NC State Building Codes Amendments - Effective 1/1/2015

(adopted through June 2014)

The following pages represent a summary of the Building Code Council adopted amendments that have been approved by the Rules Review Commission.

**SECTION VIEW OF METAL FRAME ROOF:
FILLED CAVITY FIBERGLASS INSULATION**

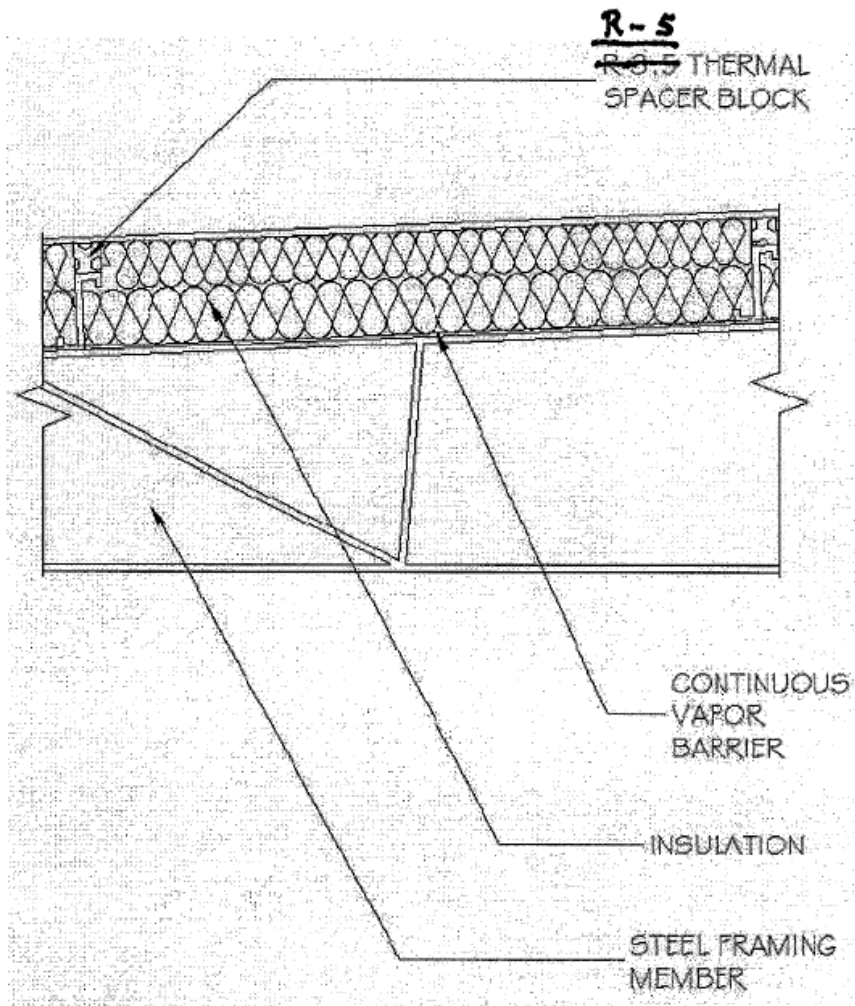
**TABLE 502.2(2)
BUILDING ENVELOPE REQUIREMENTS – OPAQUE ASSEMBLIES**

ROOFS	DESCRIPTION
R-44 <u>10</u> + R-19 FC	Filled cavity fiberglass insulation. A continuous vapor barrier is installed below the purlins and uninterrupted by framing members. Both layers of uncompressed, unfaced fiberglass insulation rest on top of the vapor barrier and are installed parallel, between the purlins. A minimum R-3.5 thermal spacer block is placed above the purlin/batt, and the roof deck is secured to the purlins. Drawings of typical details are shown in Appendix 2.2.

Revise Appendix 2.2 as follows:

**FIGURE R403.3 (1)
CONCRETE AND MASONRY FOUNDATION DETAILS**

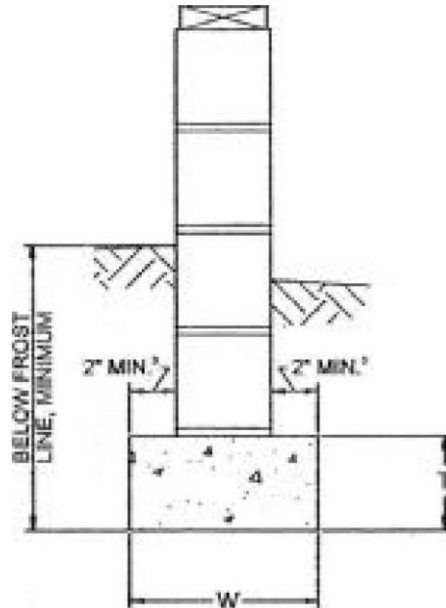
1. Foundations shall extend not less than 12 inches below ~~the natural grade or engineered fill~~ finished grade and in no case less than the frost line depth.
REMAINING NOTES TO REMAIN THE SAME
